STAFFORD LOGISTICS CENTER - TRAILER PARK

SITE PLAN

**STAFFORD LOGISTICS CENTER
TRAILER PARK
SITE PLAN
OVERALL SITE PLAN**
AURORA, CO

E0.0
16

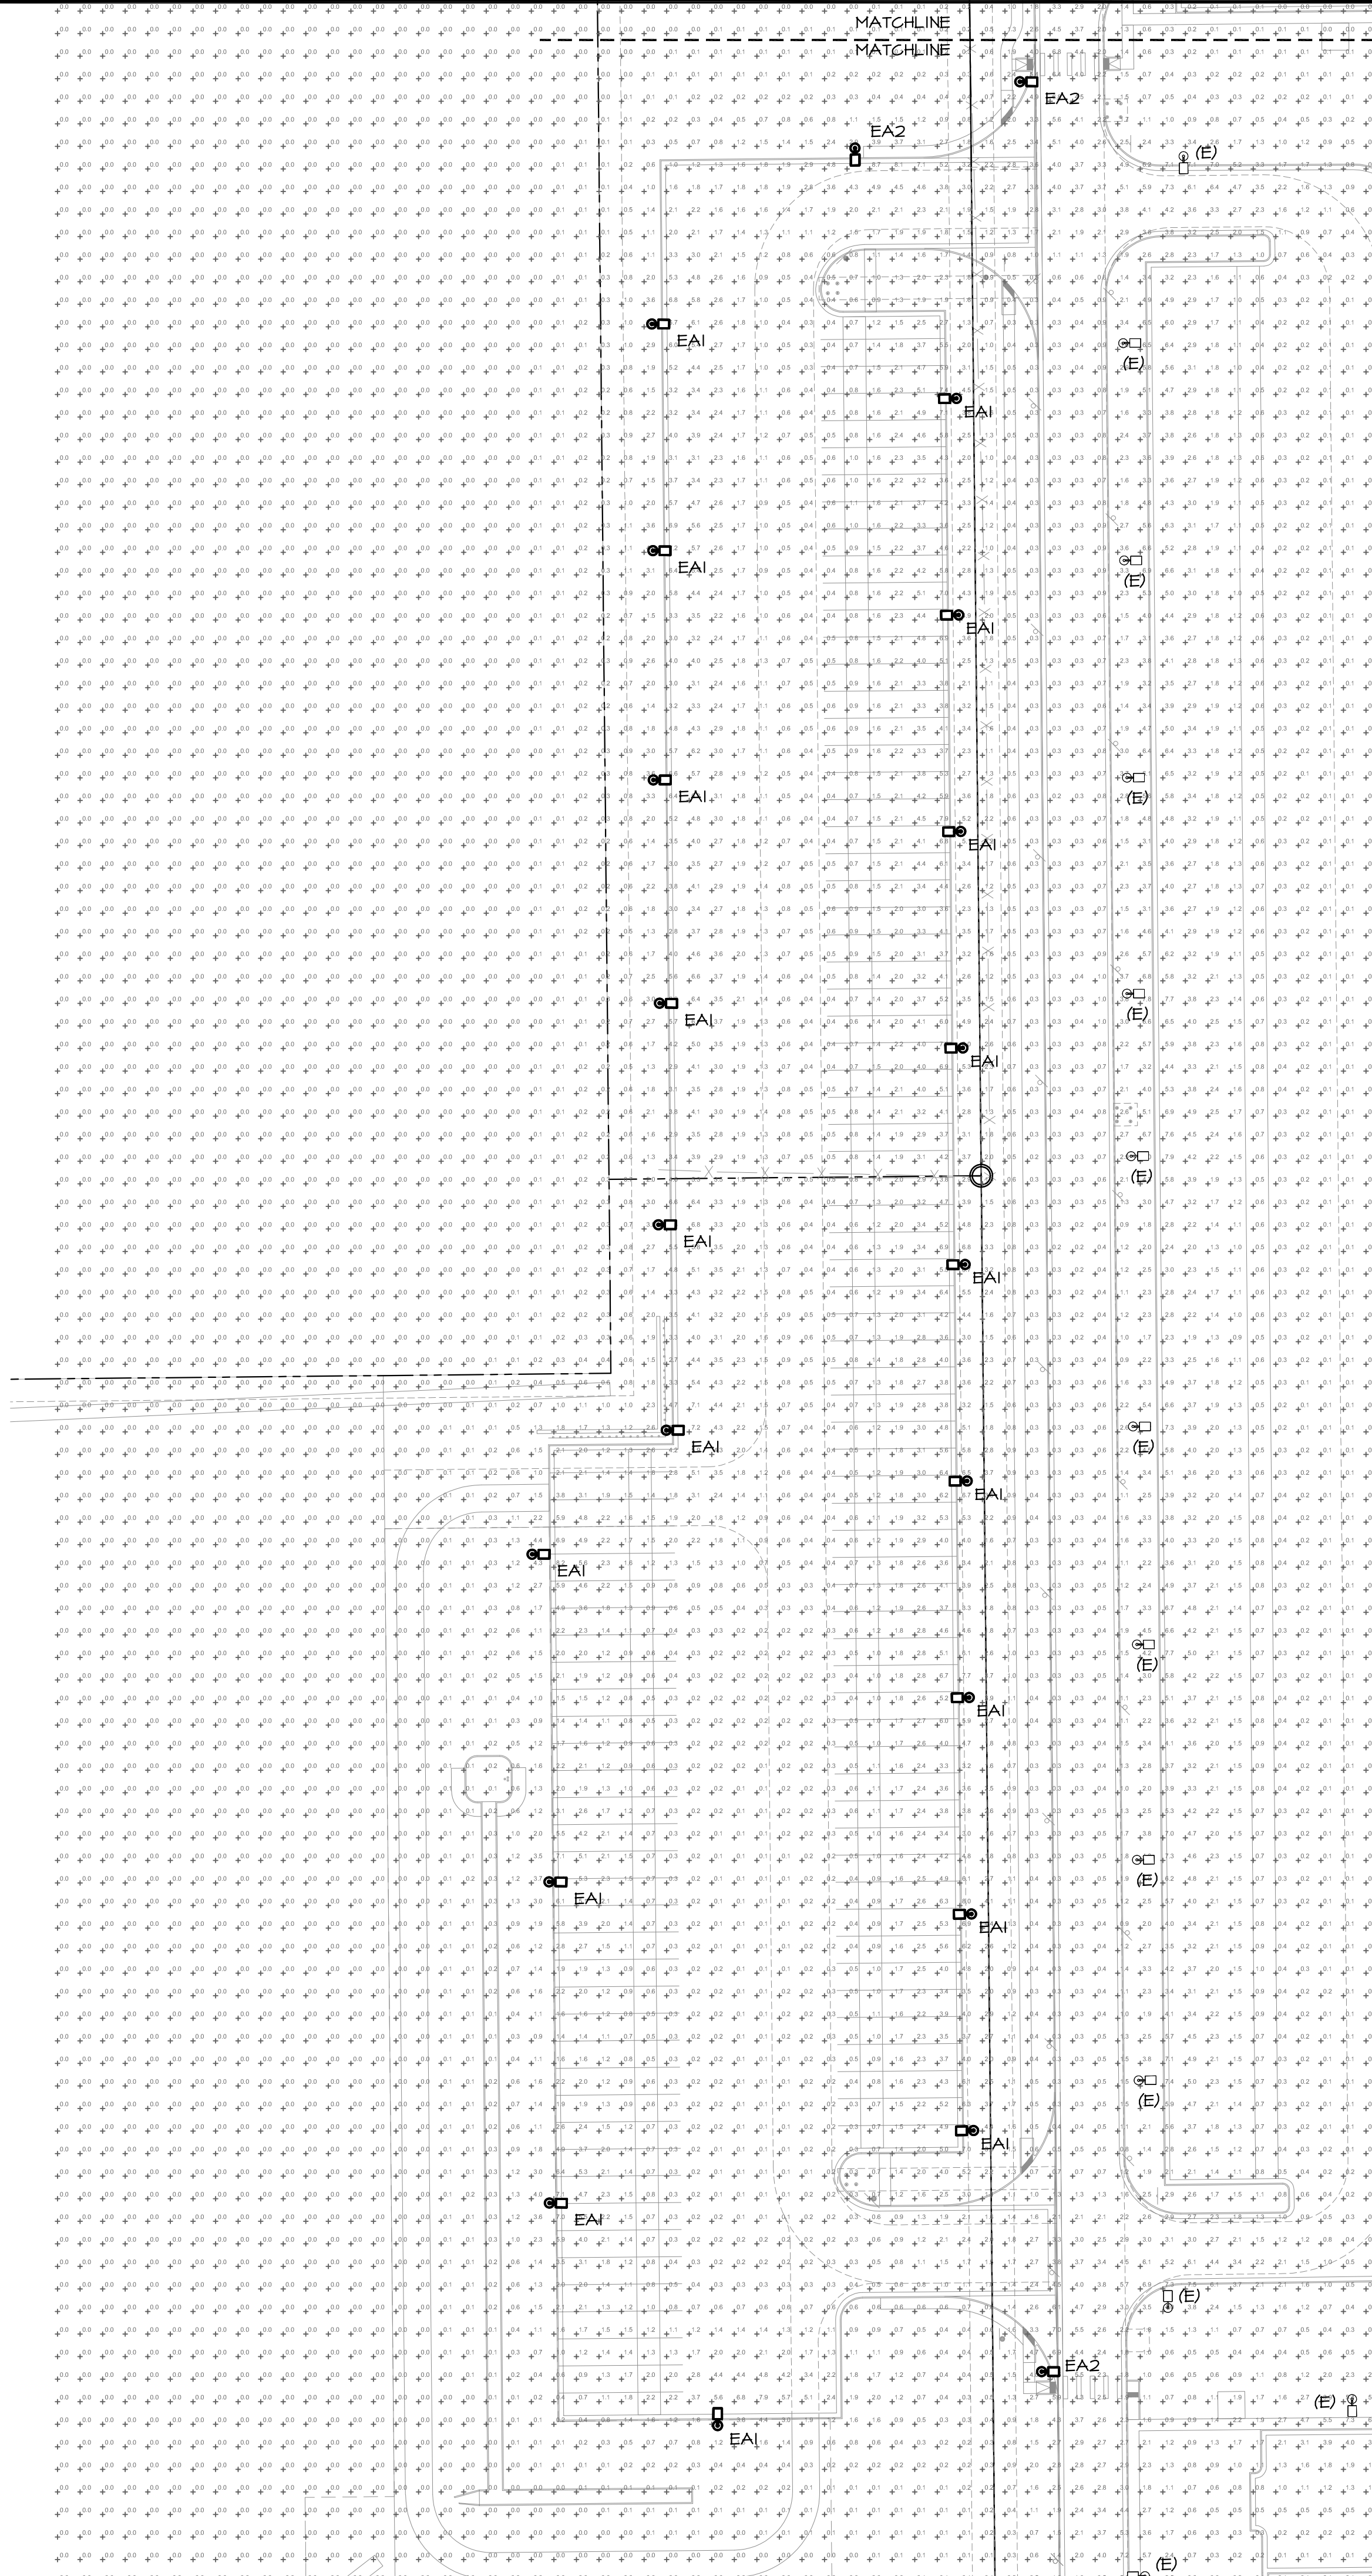
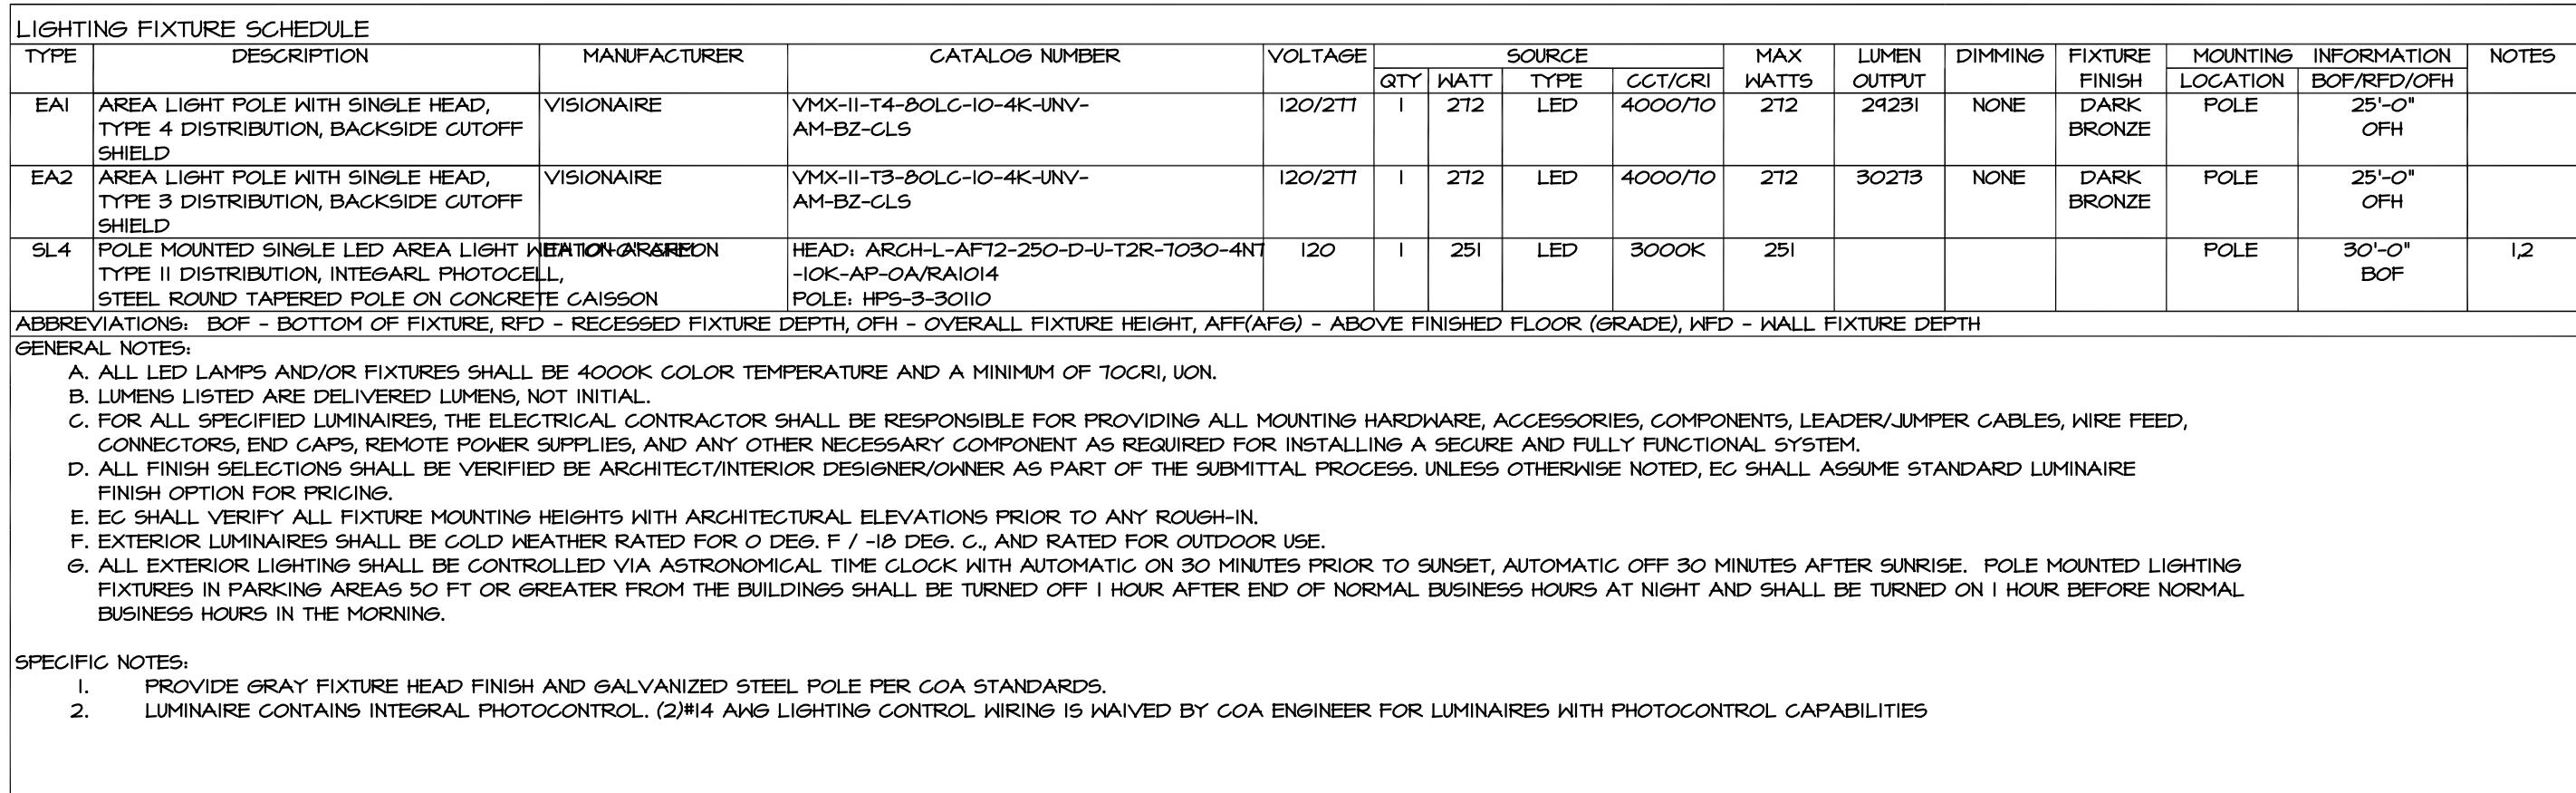
Repeat Comment:
Replace "per section 2.13.2." with "perpetuity."

Please include all missing criteria required on site plans for lighting per section 2.12.0.1

- 2.12.0.1** The following criteria and note for each proposed roadway or portion of a roadway with differing criteria within a plat/development shall be identified, reviewed, and approved by the Public Works Department as part of the Planning Review Process (site plan) prior to performing lighting design and submitting the street lighting plan:
- Roadway Classification (typical section name)
 - Adjacent Land Use Category (i.e., TOD), as applicable
 - Number of lanes
 - Back-to-back curb width
 - Pedestrian Activity Level
 - Pavement Type: R3, for all lighting calculations
- *Note: Site Plan criteria may be subject to change during the design process, and if the Site Plan and Civil Plan criteria are different, the civil plan shall be the final street lighting design criteria.

Note has been updated per comment

This is out of scope for this project. This package is intended to be used for private / on-site lighting only. A separate photometric package can be completed for the City of Aurora public street lights.
